Amendment Notice 1

Licence Number	L4605/1987/11
Licence Holder	Koppers Wood Products Pty Limited
ACN	003947680
File Number	2011/009036
Premises	Koppers Picton Boyanup – Picton Road, PICTON WA 6229 Lot 1 on Diagram 26115, Lot 520 on Plan 301384; and Lot 5054 on Plan 173762
Date of amendment	18/05/2017

Amendment Notice

Attachment 1 - Premises Plan

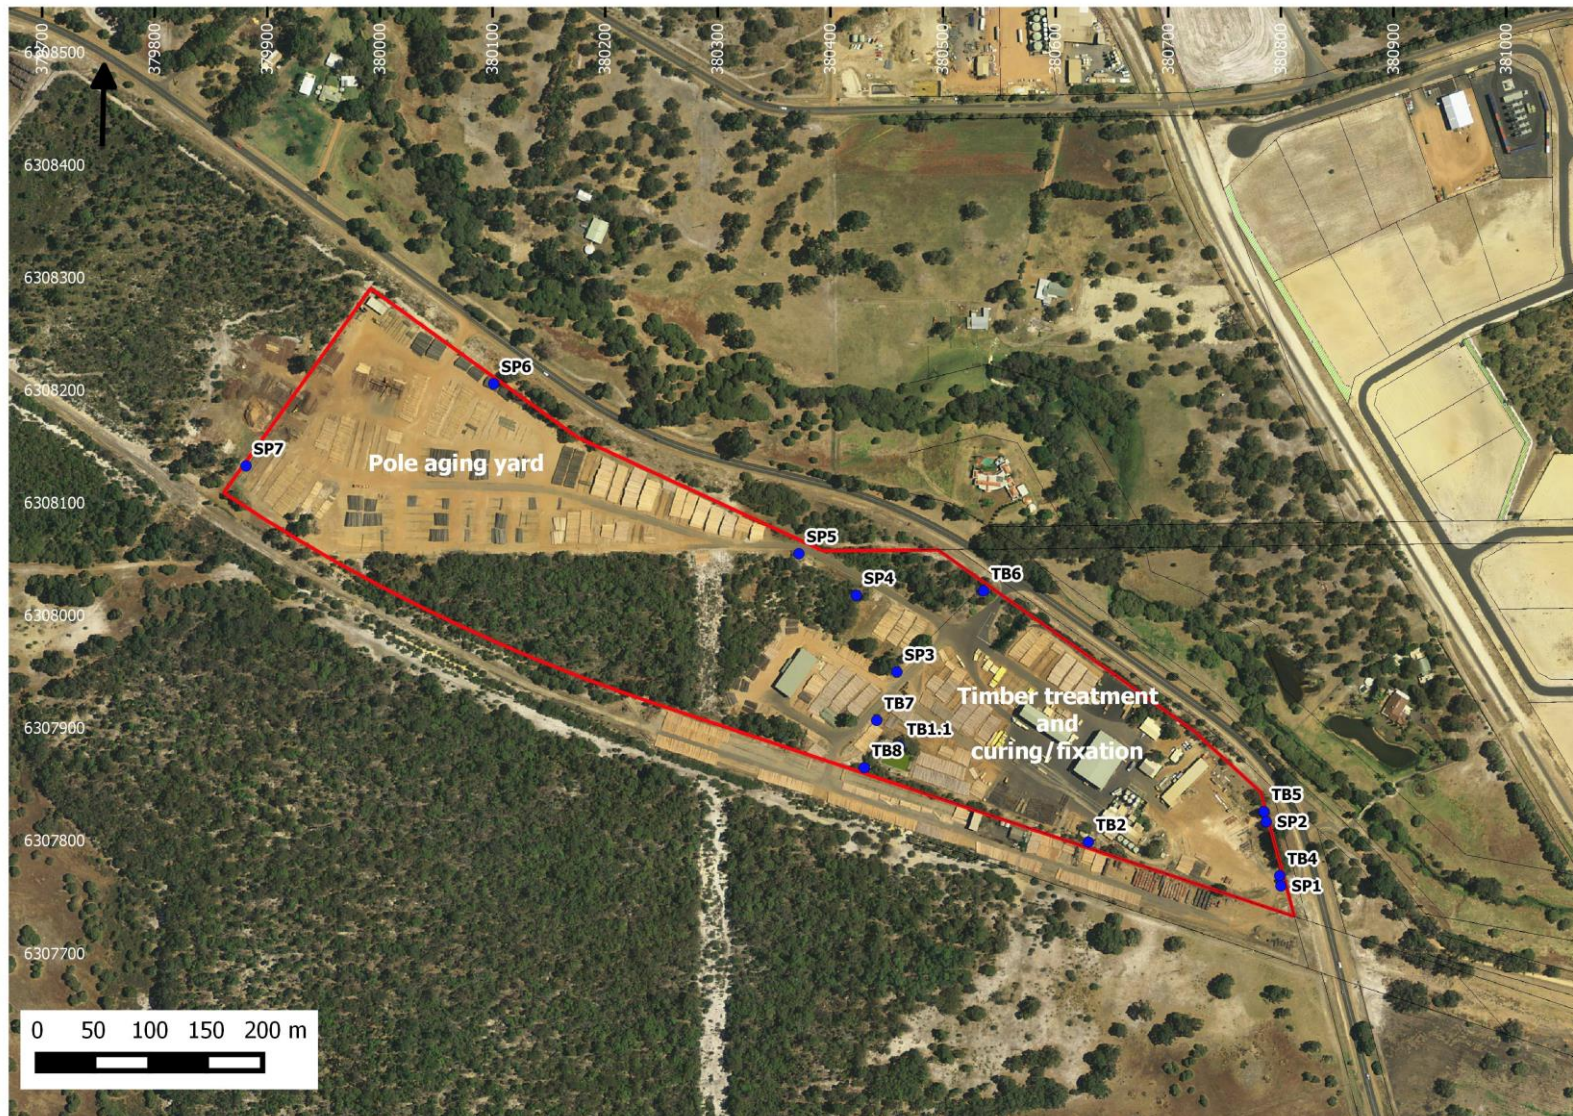
2. The Plan of Premises in Attachment 1 of the licence is replaced with the Plan of Premises in this Amendment Notice.
3. The licence is amended by the deletion of the Annual Audit Compliance Report template in Attachment 2.
4. Condition 20 of the licence is amended by the by the insertion of the red text shown in underline below:

20 The Licensee shall only discharge potentially contaminated stormwater from the authorised discharge points identified in Attachment 1 as SP1, SP2 and SP5.
